Enclosed for your information and pursuant to Part 579.5, please find our latest Service and Warranty Bulletins for May 2017.

Campaign No. 2017030016, April 2017

SUBJECT: **Model 906, Model Year 2017
Retrofit SRS Control Module Reinforcement Plate/Protective Bracket**

Figure 1

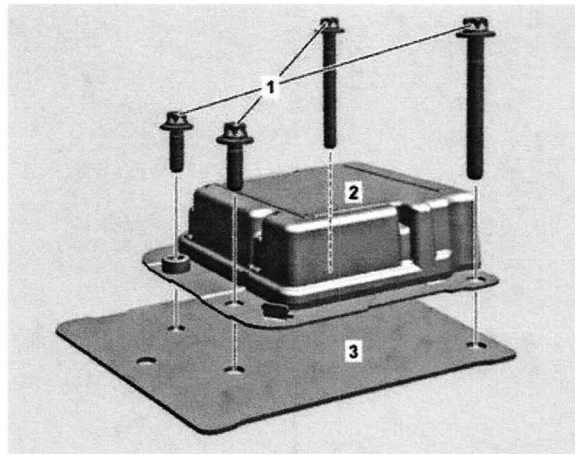
1.  Remove SRS control module; refer to WIS: AR91.60-D-0615A
 **Note:** (regarding referenced WIS document): It is not necessary to remove door sill trim.
2.  Retrofit SRS control module reinforcement plate/protective bracket (3, Figure 1): Align reinforcement plate/protective bracket (3) with threaded mounting bores of SRS control module (2) at control module's installed position.

3.  Reinstall SRS control module (2, Figure 1) on top of reinforcement plate/protective bracket (3):
 Torque mounting bolts (1) to: 10 Nm.
 **Note:**
 Check for correct seating of reinforcement plate/protective bracket (3) when installing SRS control module (2).
4.  Reinstall remaining components in reverse order.

Figure 2

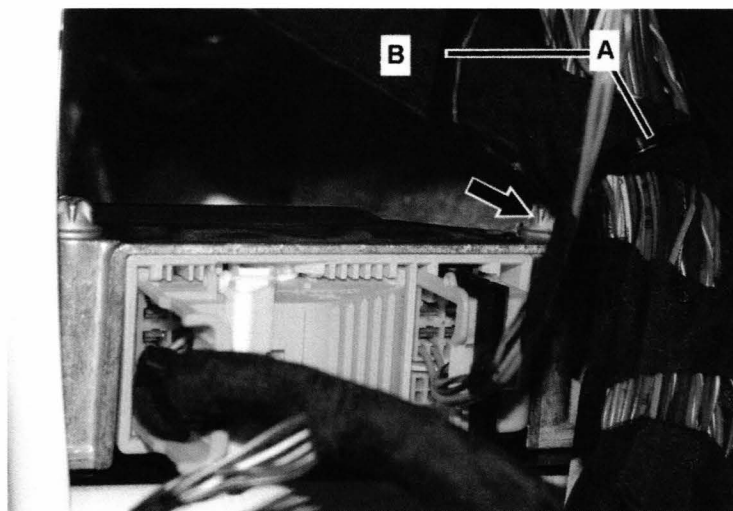
- In order to gain access to covered SRS control module mounting bolt (arrow, Figure 2) cut cable ties (A) and remove from them their mounting clips, then lift up interior harness (B).
- Be sure to reposition interior harness (B) back to its' **original position** and **secure to existing cable tie mounting clips with new cable ties.**

Figure 1

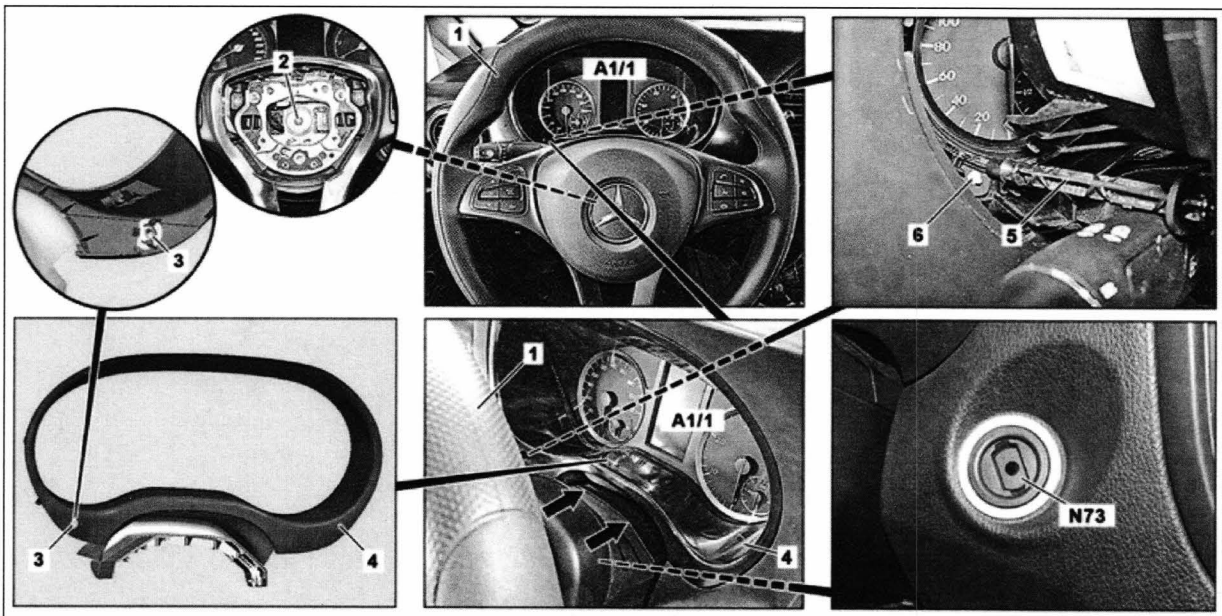
1.  Replace steering wheel (1, Figure 1), refer to WIS: AR46.10-S-0100E.
 **Note:**
 Install new steering wheel mounting bolt (2) and torque to proper specification.

**Note:**
 The adjustment shaft extension (5, Figure 1) is retrofitted. To attach the adjustment shaft extension (5) to the instrument lighting adjustment shaft (6), the cover (3) on the trim (4) must be removed.

5. Disconnect XENTRY Diagnostics.
6.  Perform function test of instrument cluster (IC) control unit (A1/1, Figure 1) and steering wheel (1).

Figure 1

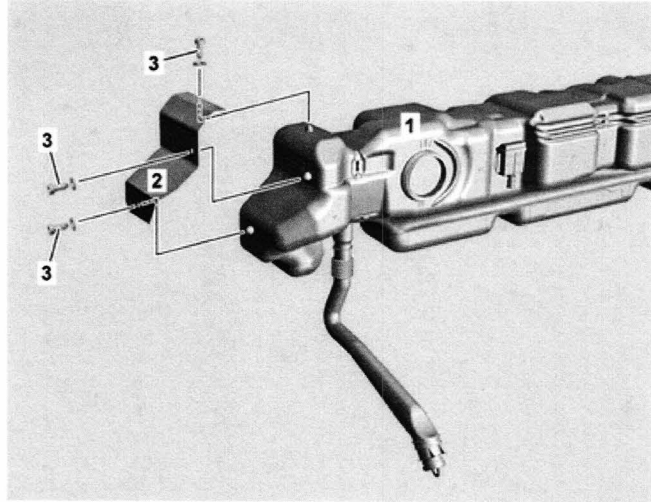
1.  Remove fuel tank (1, Figure 1) refer to WIS: AR47.10-D-4100SD.

2.  Mount heat shield (2, Figure 1) to new fuel tank (1) using screws (3) with washers.
3.  Install new fuel tank (1).

Figure 2

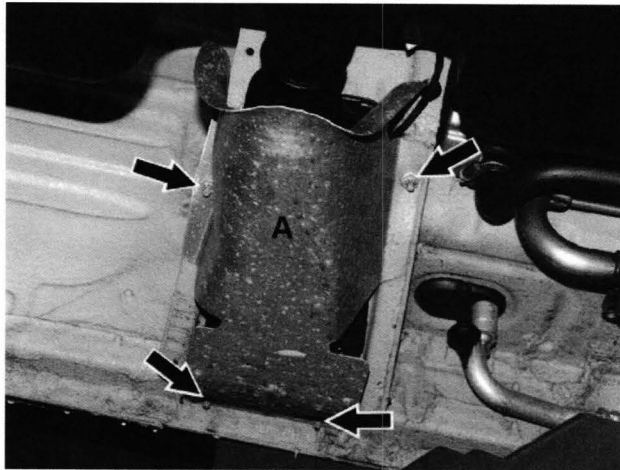
- Bolts for fuel tank tensioning straps
- Union nut and the sealing ring for the fuel delivery module.
- Protective shield nuts (arrows, Figure 2) for filler neck.

Figure 1 (1 Drive shaft, 2 Drive shaft strap/loop, 3 Bolts)

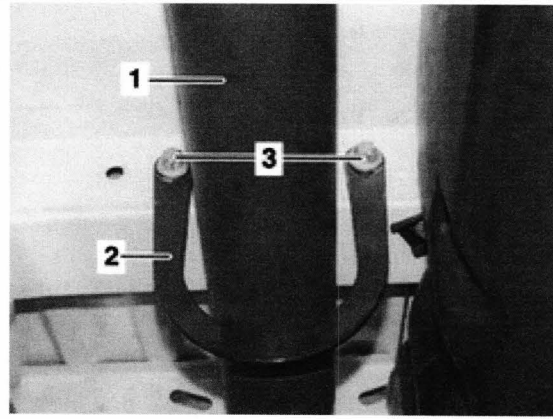
-  Retrofit drive shaft strap/loop (2, Figure 1) to cross member with mounting bolts (3).
 Torque mounting bolts (3) to: 70 Nm.
